Inspection Report for North Sturbridge Road Solar Facility

NPDES ID No.: MAR10031G

Inspection Date: 12/27/2021

**FIGURE 1:
SWPPP
INSPECTION
SKETCH
12/27/2021**

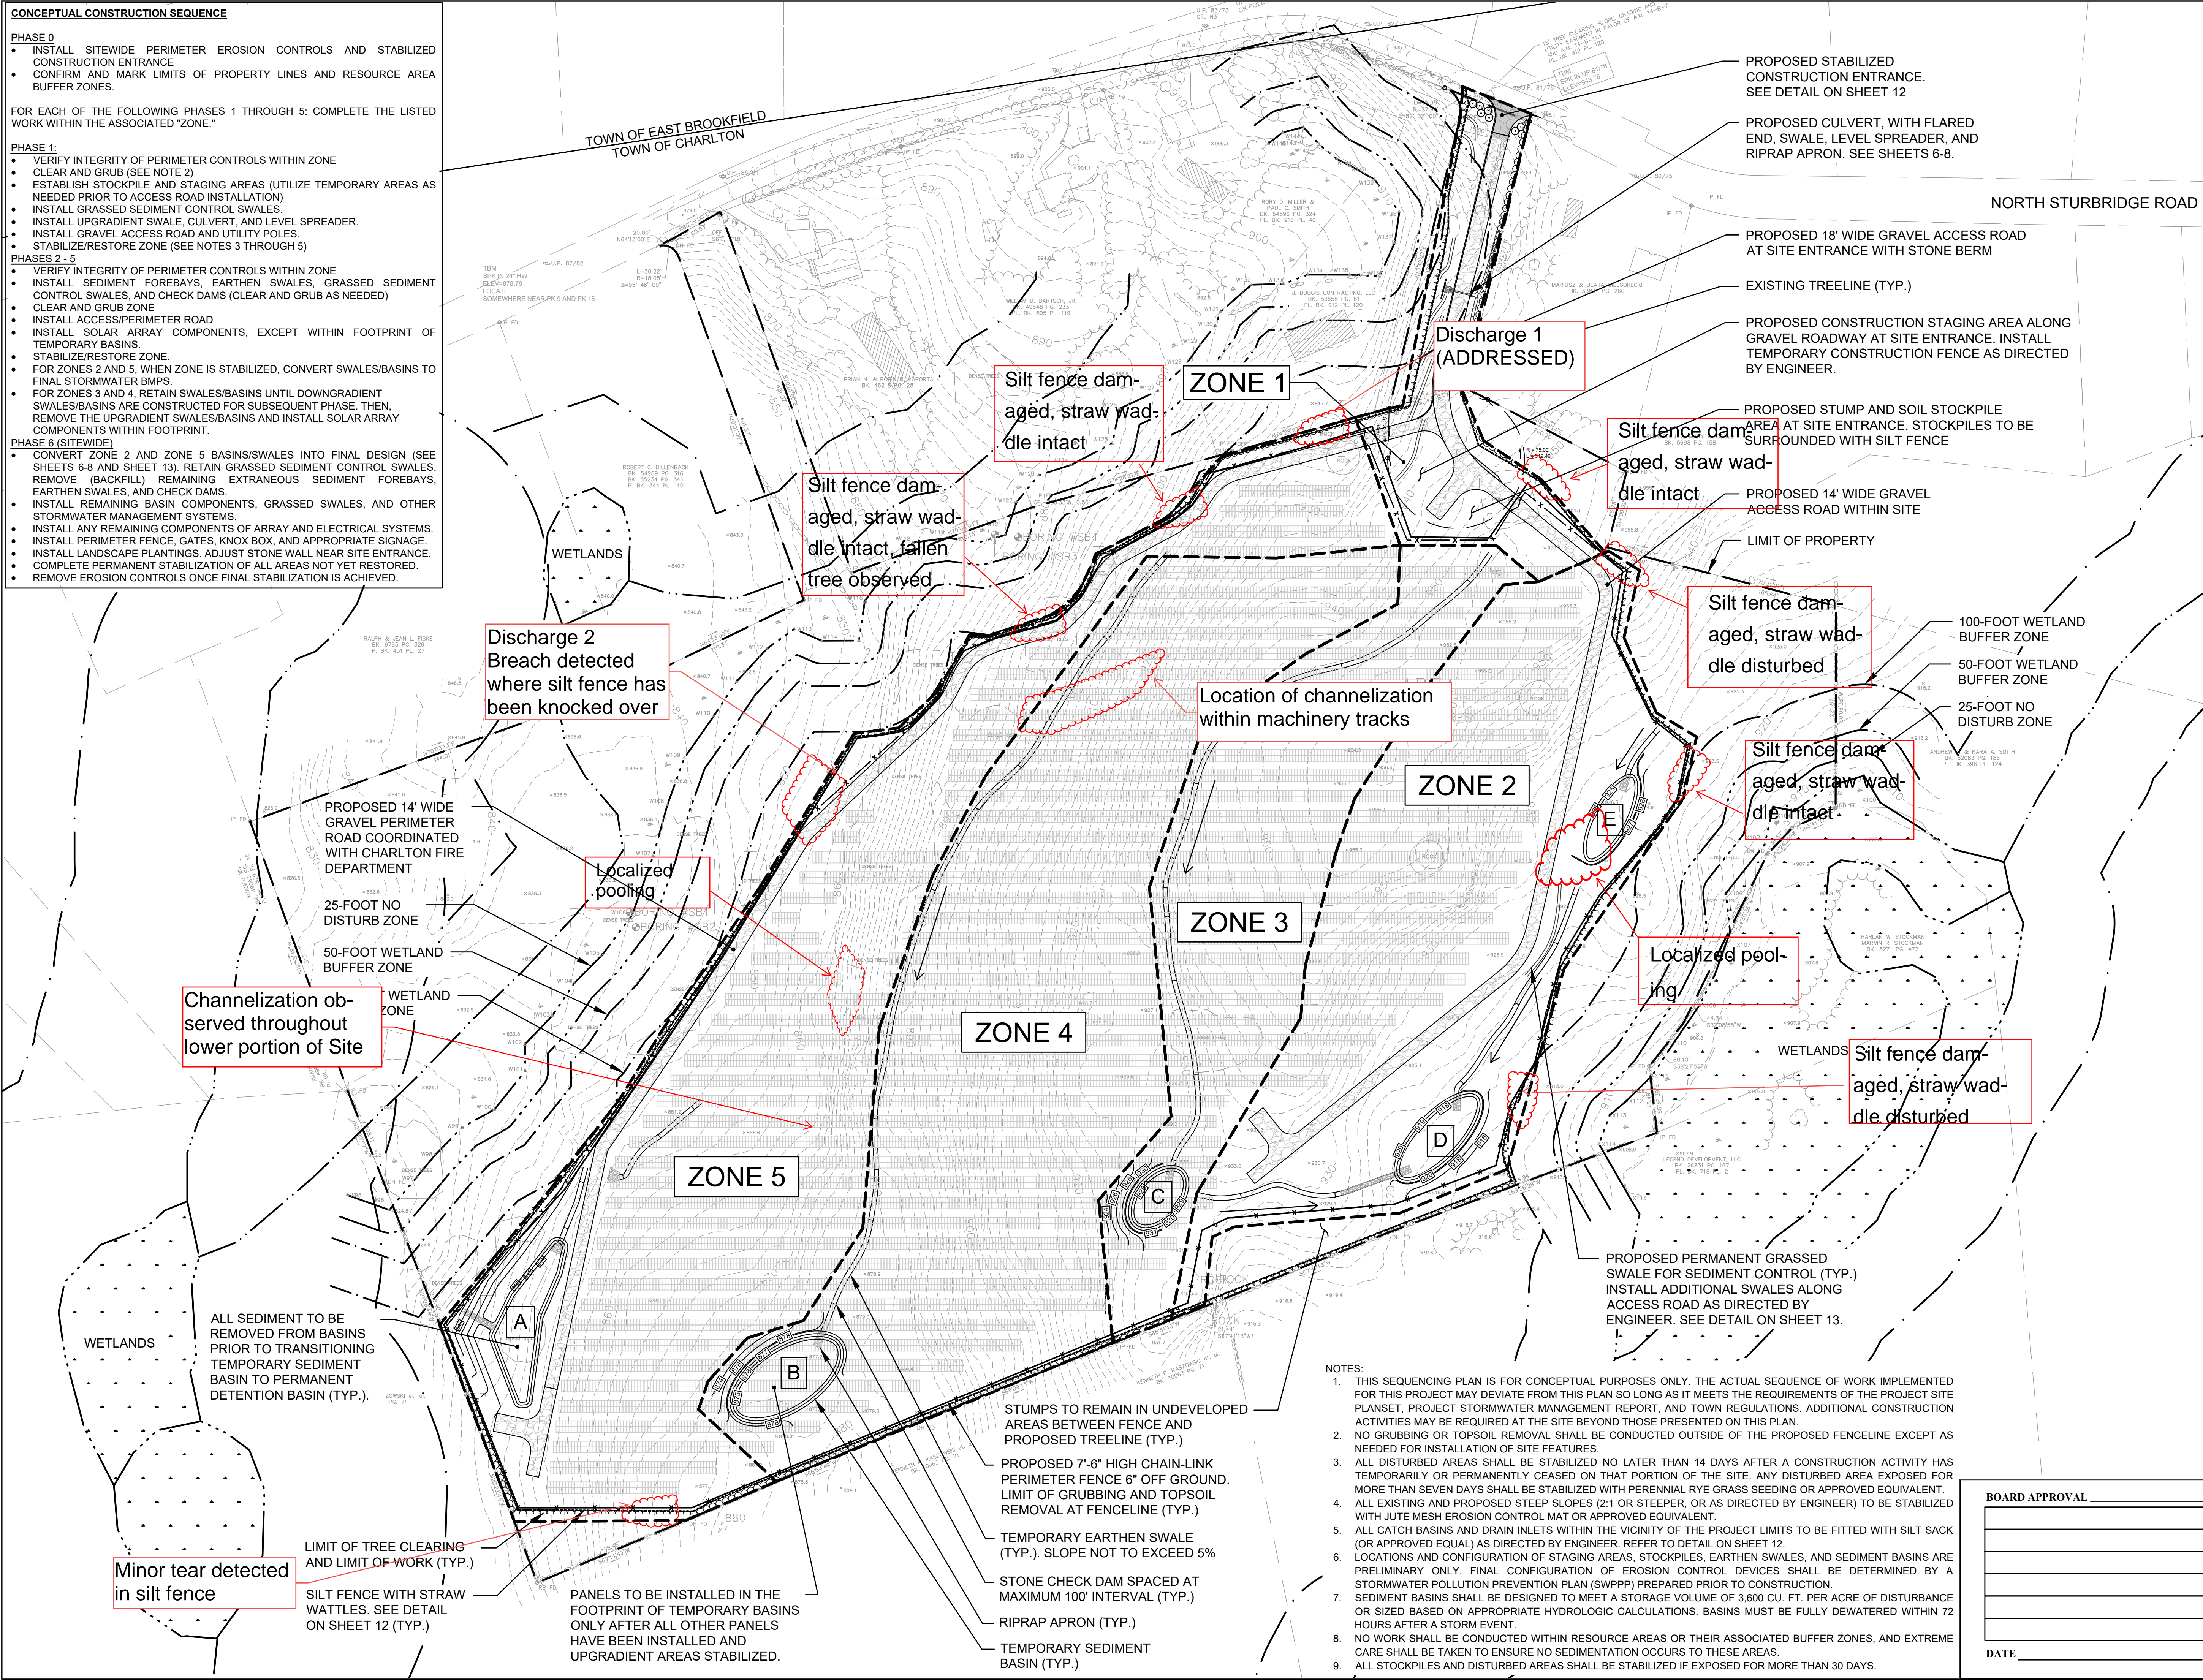
2. Informal access road along northern portion of the Site	Straw mulch or hydroseed	<input type="checkbox"/> Yes [Enter date] <input checked="" type="checkbox"/> No	Erosion channels are beginning to form within upgradient portions of the informal access road (Figure 1). The contractor indicated that stabilization by smoothing out soils and seeding or spreading mulch would occur on 7/30/2021. Stabilization of this area has not been initiated. After inspection of the area on 8/24/2021, it was determined that
